RFI

RFI #: 32
 Date: 1/12/2012
 Job: EB-02 Keller Springs Lofts
 Phone: 877-777-5115

CC: Erik Earnshaw (BGO)
 Subject: B2 master Bathroom Toilet

Drawing: A2.7
 Cost Impact: None
 Spec Section:
 Schedule Impact: None

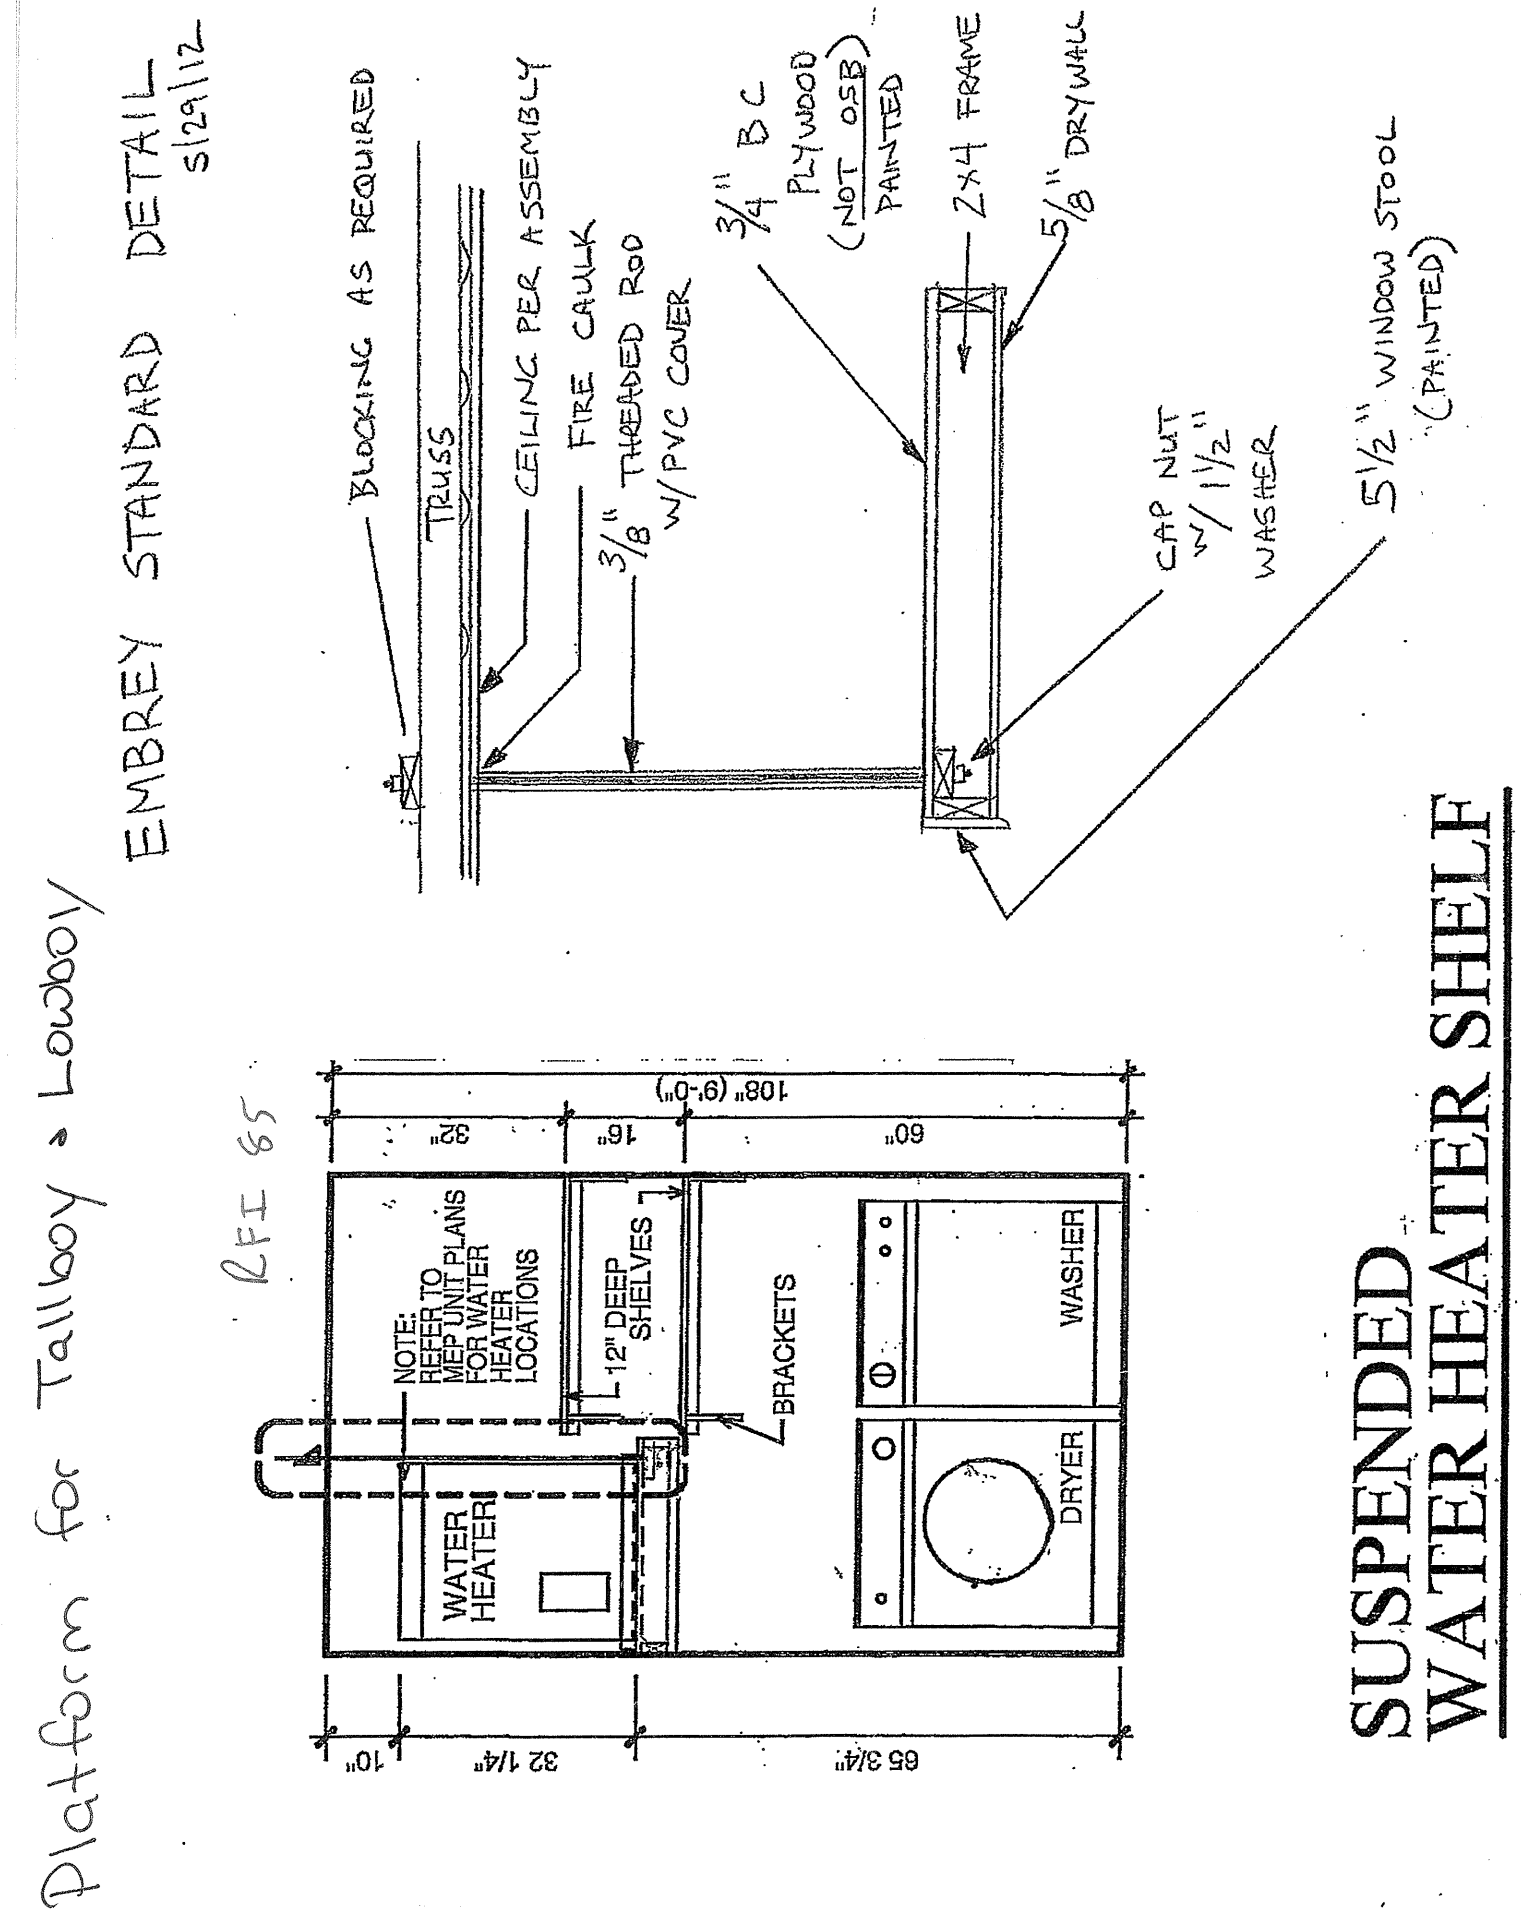
Request: Please provide the door type for the Bath #1 door into the toilet room.
 Date Required: 5/29/2012

Response: See sheet 2.7
